Staff Report

To: BOZAR
From: Jessie Earley, Town Planner III
Meeting Date: DRC, April 21, 2025
RE: 75 Pyramid Way, Preliminary Review

PROJECT TITLE: Guidone (75 Pyramid Avenue)

Proposed Site plan

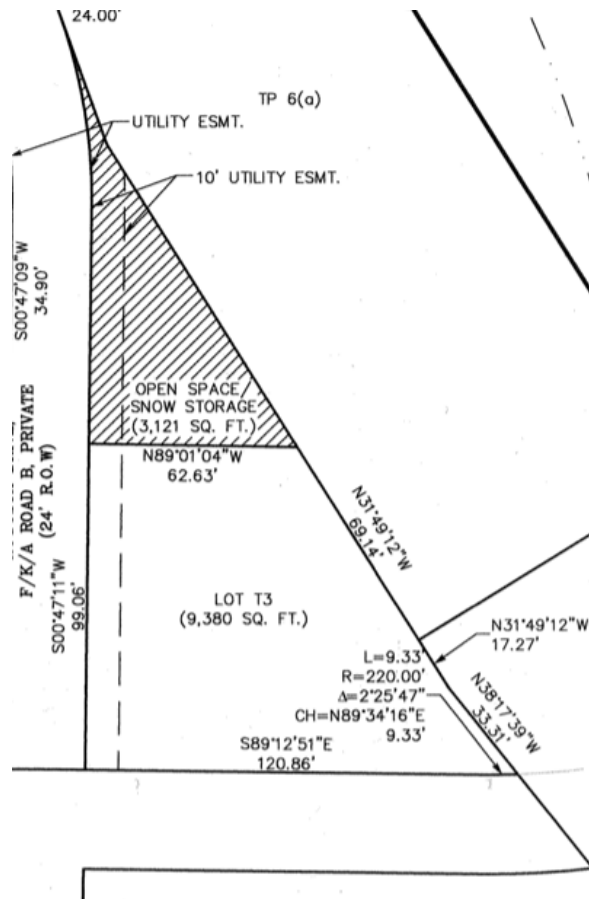
GL	Staff Analysis	DRC Recommendation
Topography	On the southeast corner of the lot, the grade is 8867', which steps up to 8879' on the northeast corner. Then, this transitions back down to 8876' to the west and down to 8871' on the southwest corner. Over the course of the primary building footprint, the grade changes from 8872'

<p>to 8879'. The average grade for the site is noted as 8875'. Staff agrees with this assessment for the primary building for the purposes of measuring FAR.</p> <p>It is difficult to decipher from the site plan, but it looks like the majority of the grade for the north accessory building (garage) is 8880'. Confirmation is needed.</p> <p>For the southeast accessory (shed), the bulk of the grade for measuring FAR appears to be 8871'. Confirmation is needed, as it is not shown on the elevations or section.</p>

2.8 Drainage	Drainage information has not been provided. Drainage arrows for the site must be shown.	
Easements	There is a 10' utility easement for the west side of the lot. This must be included on the site plan.

2.16 a./ 2.20 Native plantings	Ground cover is not noted. Native materials are encouraged by the GL.	
2.16 e Pervious materials 2.28 e & f Parking substrate	<p>Walkway (257.9 sf), parking/drive (841.88 sf) and patio (351.88 sf) are noted as gravel. Walkway and the area for the garage are needed. Board members can discuss if the parking/drive in the south portion of the yard is excessive, as only one exterior parking space is required. Additional parking spaces are not permitted.</p> <p>The patio on the north and east and walkway between buildings (1436.13 sf) is noted as pervious pavers. This area is a large amount of hardscape. Discussion is encouraged. It is appreciated that this material is pervious.</p>

compliance with the night sky ordinance.	
Solar 2.10	Panels have been shown on the south elevation of the accessory building/garage. Support.	
Utilities	There is a 10' utility easement for the west side of the lot. This must be included on the site plan.	
2.7 Snow Storage	Snow storage is not provided onsite and must be to ensure it meets the 33% requirement of the areas to be plowed.

Northeast perspective

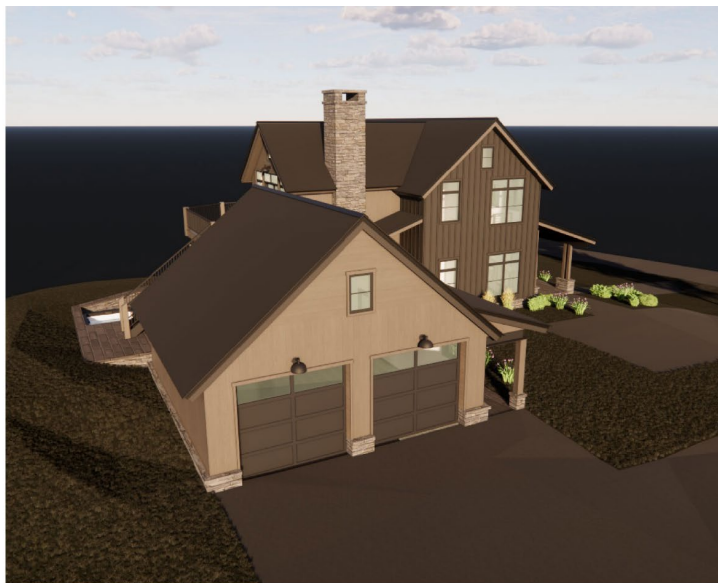
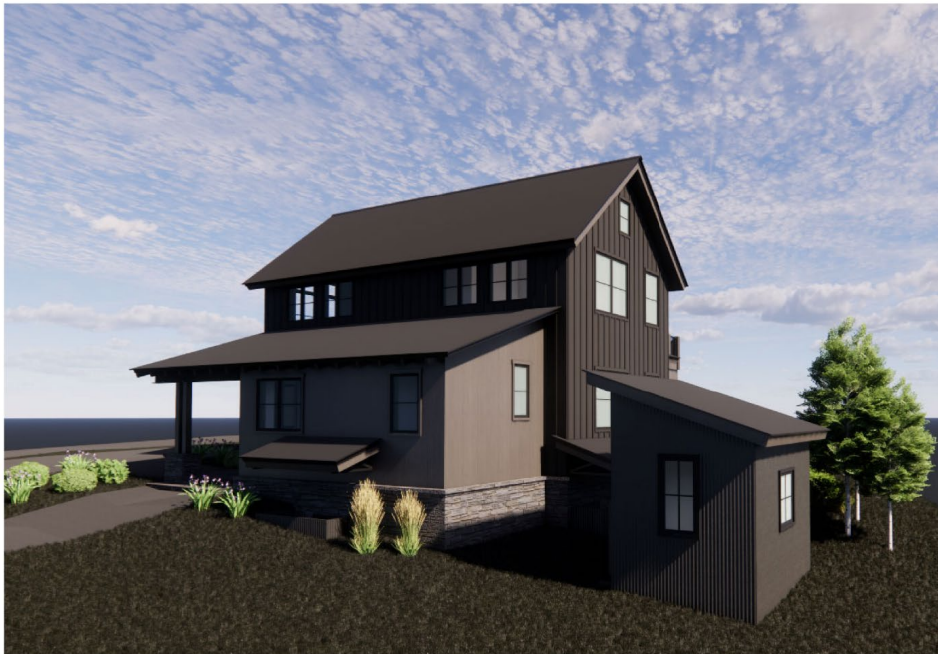
GL	Staff Analysis	DRC Recommendation
4.33-4.34	Consideration of whether the forms achieve relationships with historic buildings are in GL 4.33 and 4.34. 3D drawings are helpful to assess this.	
4.34 Discernable primary module	The front module, encouraged to be the discernable primary module appears to be met per GL4.34.

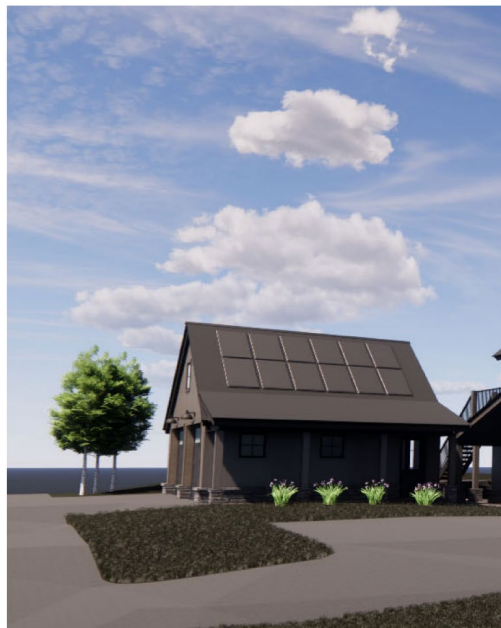
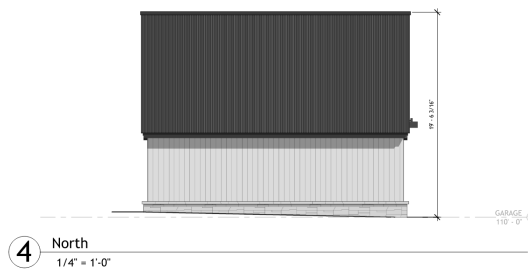
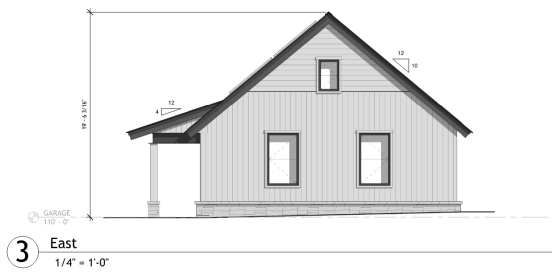
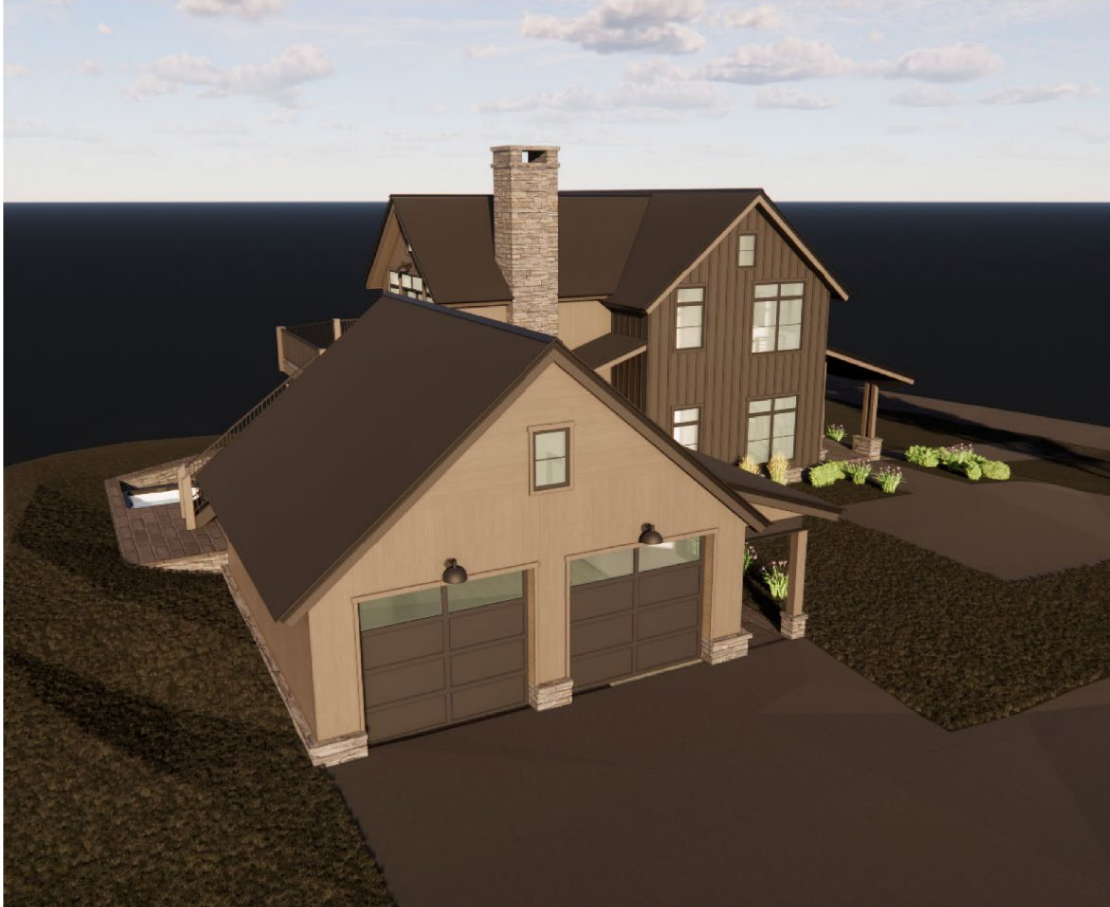
GL	Staff Analysis	DRC Recommendation
4.84 Smaller in size	The proposed building is smaller in scale than the primary building, as requested by the GL.	
4.85 Rear of the site	This building is located on the rear/north	
4.86 Vary appearance	This is the first accessory building within this zone. So, the context is being developed.	
4.89 d. porches	The small, covered entry for this building can be supported.

4/21 DRC elevations

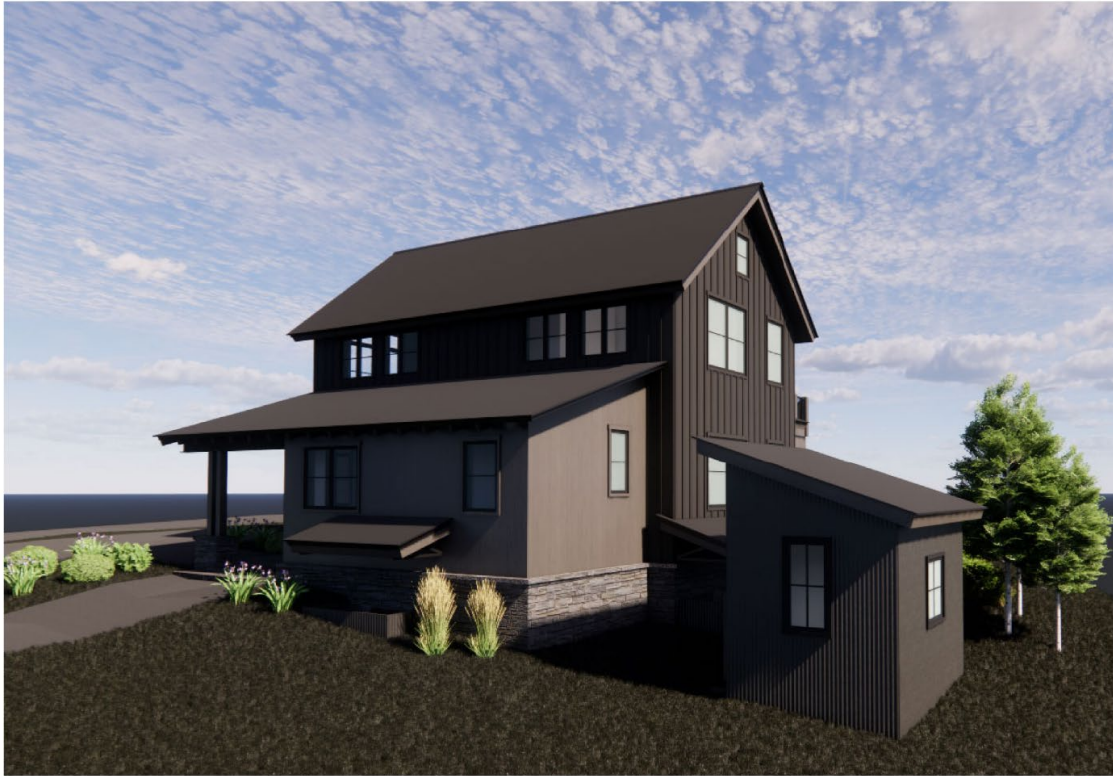
GL	Staff Analysis	DRC Recommendation
4.84 Smaller in size	The proposed building is smaller in scale than the primary building, as requested by the GL.	
4.85 Rear of the site	This shed is pushed back 2'6" from the front of the building. There are similar situations within the Paradise Park area. This lot is unique and presents challenges for access.	
4.86 Vary appearance	As seen in the perspectives, this building will vary in appearance from other buildings on this portion of the block.	
4.89 d. porches	The small, covered area for the air source heat pumps for this building can be supported.
